Service Bulletin

ISSUE NO: JD 04/92

- MODEL : XJ6 / XJS / S.III V12 (AIR CONDITIONED MODELS)
- SUBJECT : BLOWER MOTOR ASSEMBLIES
- CUSTOMER CONCERN : Brush gear noisy operation, ie: low speed ticking / squeak.

Service Bulletin

FIG 1

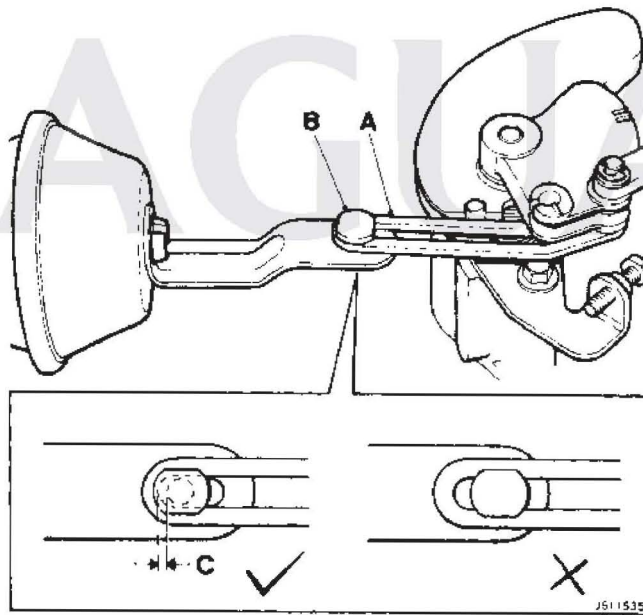
Should customer complaints be received of an increase in the cruise control response time and a degree of hunting of the set speed, the cruise control actuator linkage adjustment should be checked in accordance with the following procedure, before taking any further action.

Dealers should ensure that the clearance between the end of the actuator to throttle link slot (A Fig 1) and the shoulder bolt (B Fig 1) is 0.5mm to 1mm (C Fig 1).

Fig. 1

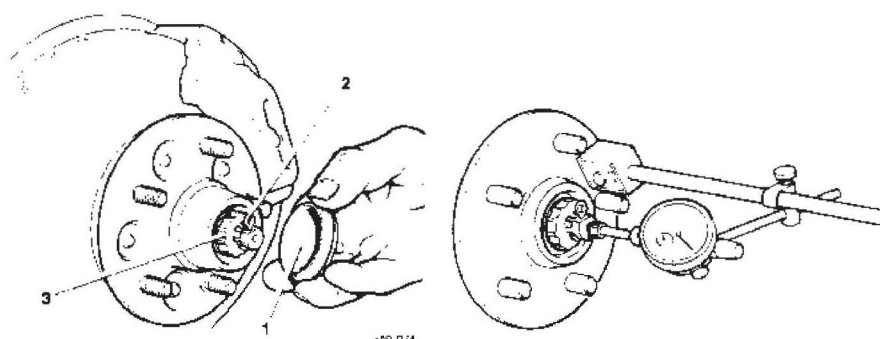
The following instructions supersede all previous instructions provided in service manuals. Manuals will be updated at the next reprint.

Front hub end float on the above models should be set between 0,0254 to 0,0762mm (0.001 to 0.003in). To achieve this in service use the following method:

Prise off the hub grease cap (1 Fig. 1).

Fit a Dial Test Indicator (DTI) to the hub (Fig. 2).

If the reading is within the specification quoted there is no need to carry out the adjustment. If not, remove the hub nut split pin and cover (2, 3 Fig. 1).

Adjust the nut, as necessary, to give a reading of 0,0508mm + / - 0,0254mm (0.002in + / - 0.001in).

Always try to achieve the mid-point of the tolerance i.e., 0,0508mm (0.002in).

Fig. 1

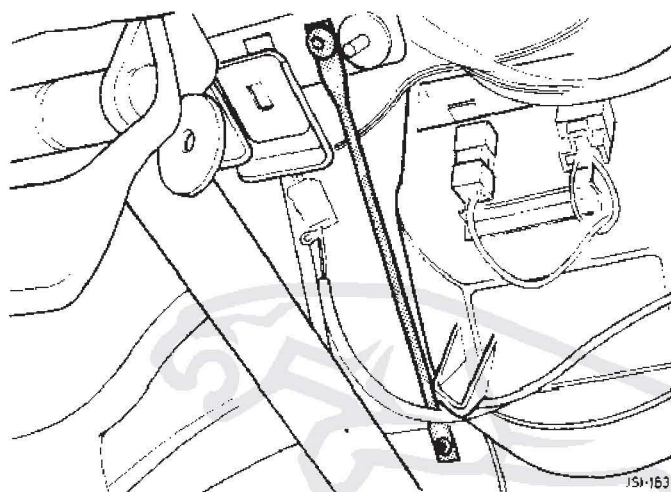
The repair operation time for renewing the driver's side blower motor assembly has changed on all XJ6 Vehicles from VIN 629286.

Open the bonnet and disconnect the battery earth lead.
Remove the driver's side dash liner.
Remove the retaining clip from the air conditioning unit's pliable trunking.
Displace the pliable trunking from the air conditioning unit.
Displace the relay bases from their mounting brackets.
Cut and remove the ratchet straps securing the brake switch harness.
Disconnect the vacuum hose from the blower motor assembly servo unit.
Disconnect the blower motor multi-way connectors.
Undo and remove the steering column lower mounting securing nuts.
Undo and remove the steering column upper mounting securing nuts.
Lower the steering column assembly.
Retrieve the column upper packing shims.
Remove the washer bracket from the column.
Manoeuvre the steering column towards the centre of the vehicle for access.
Undo and remove the steering column outer stabilizer bar's upper and lower securing nuts.
Displace and remove the steering column stabilizer bar (Fig. 1).

Fit and align the steering column stabilizer bar and tighten the securing bolts (10 – 14 Nm).

FIG 1

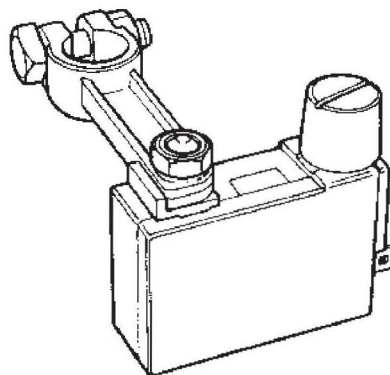
Owing to the relocation of the battery into the boot at 93 MY, a revised battery transit relay has been introduced, (see Fig 1).

FIG 2

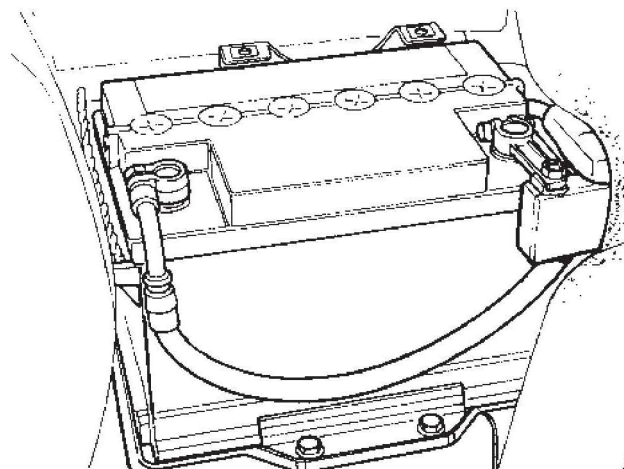
1. Open the boot and remove the battery cover, (see Fig 2).
2. Remove the negative lead from the battery.
3. Disconnect the transit relay from the battery.
4. Remove the white / yellow (W/Y) ignition wire from the transit relay.

FIG 3

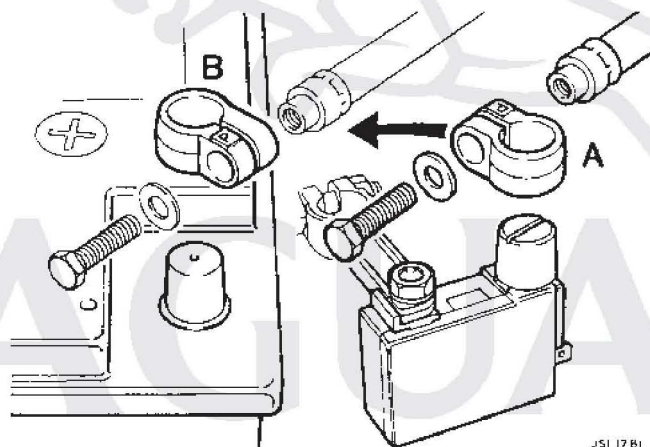
5. Remove the positive lead from the transit relay terminal post, (A, Fig 3).
6. Reverse the positive lead clamp and refit the clamp to the positive lead (B, Fig 3).

FIG 4

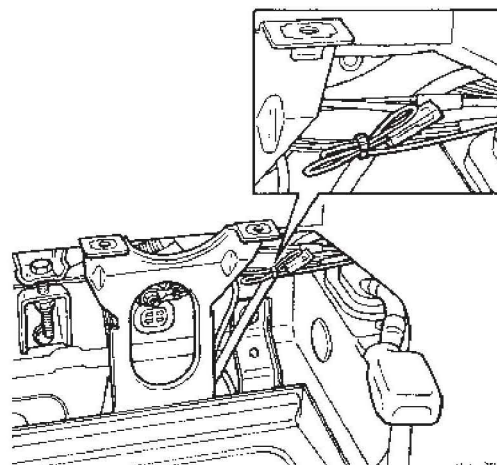
7. Displace the battery.
8. Tie back and secure the white / yellow (W/Y) ignition wire, (see Fig 4).

FIG. 1

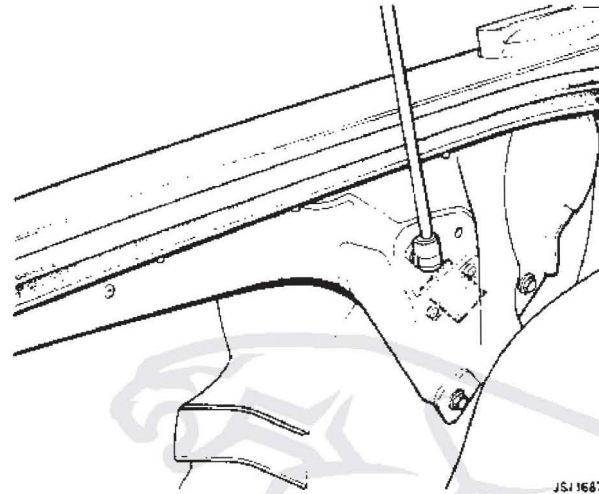
From VIN 179737 (92MY Facelift XJS), the stop light failure sensor module is located in the boot of the vehicle, attached to the inside of the boot side reinforcement panel (drainage channel) L.H. (Fig. 1).

FIG. 2

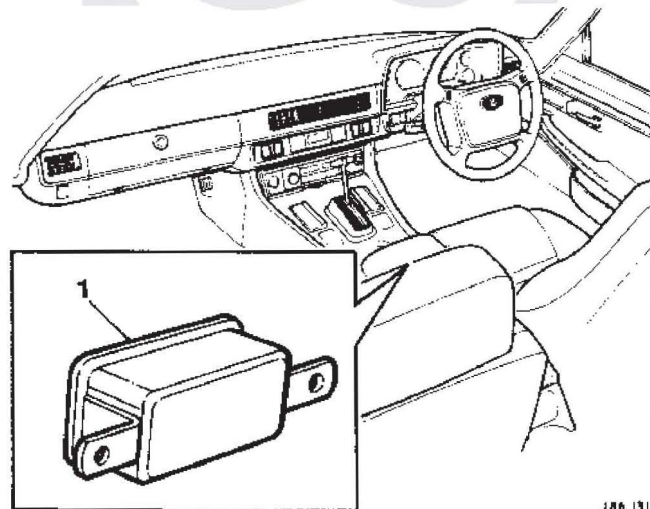
Prior to VIN 179737 (90MY XJS), the module is located beneath the centre console veneer finisher, attached to a bracket in front of the stowage compartment (Fig. 2).

FIG. 1

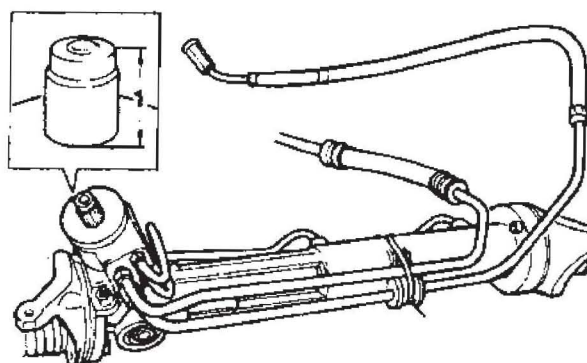
The ZF Phase 2 Steering Rack (Fig. 1) is added to the 1994 MY specification. The rack body consists of two aluminium pressure diecastings; the rack mounting is unchanged. The pinion height (1, Fig. 1) is increased by 7mm; the steering column is altered to accommodate this change. The fluid pipe union positions in the valve block are also altered, with the fluid pipes being modified accordingly. The steering rack assembly is a non-serviceable item.

FIG. 2

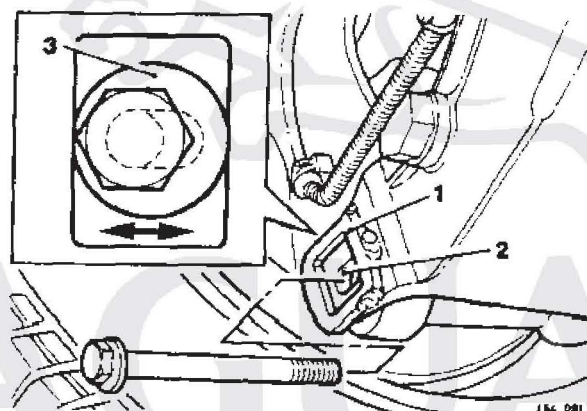
The lower suspension arm has a plate, with a rectangular recess machined in the centre, added to the rear pivot eye (1, Fig. 2). The suspension arm pivot bolt hole (2, Fig. 2) is elongated, horizontally, at this point.

The pivot bolt has an integral eccentric (3, Fig. 2) below the bolt head, which, when in position in the plate, has a slight clearance at the sides but full clearance at the top and bottom. Rotation of the bolt head, with the eccentric constrained between the vertical faces, causes the bolt shank to be moved in the horizontal plane, thus displacing the hub carrier and effecting wheel alignment adjustment.

Fig. 1.

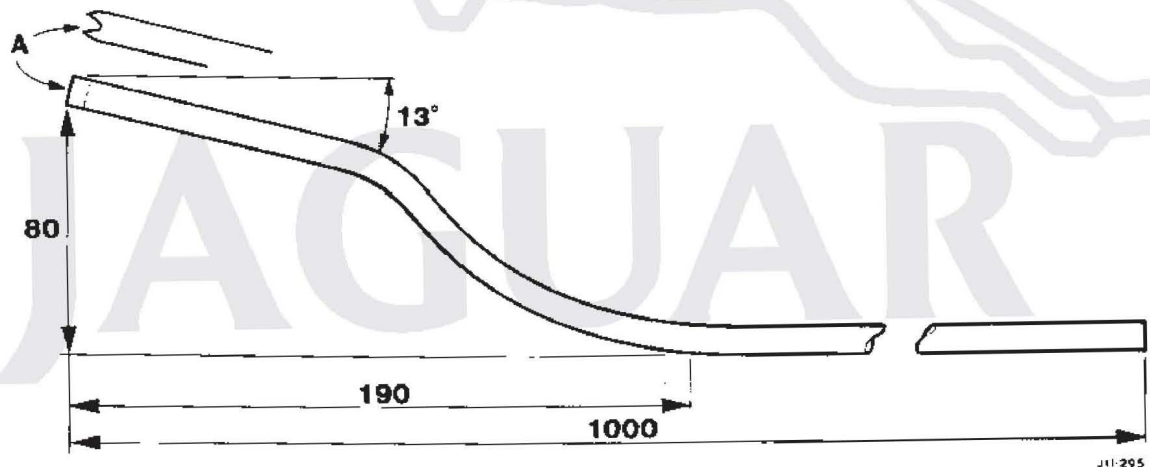
7. Release the RHS catch by operating the latch arm directly by hand.
8. Using the locally-made release tool illustrated in Fig. 1. below, the LHS catch may be released after passing the release tool across the top of the engine. The notch on the end face of the tool prevents slippage from the catch.
9. Remove the bonnet by lifting it up and away from the engine compartment aperture.
10. Trace and rectify the release problem.
11. Refit and adjust the bonnet to the aperture.
12. Refit the front grille.
13. Reconnect the battery and refit the battery cover.
14. Re-code the radio; re-set the clock.

The tool illustrated above should be locally manufactured from a length of steel rod, 6.00mm diameter, approximately 1000mm long. The overall length, however, is not critical, provided that the tool is sufficiently long to provide access across the engine compartment.
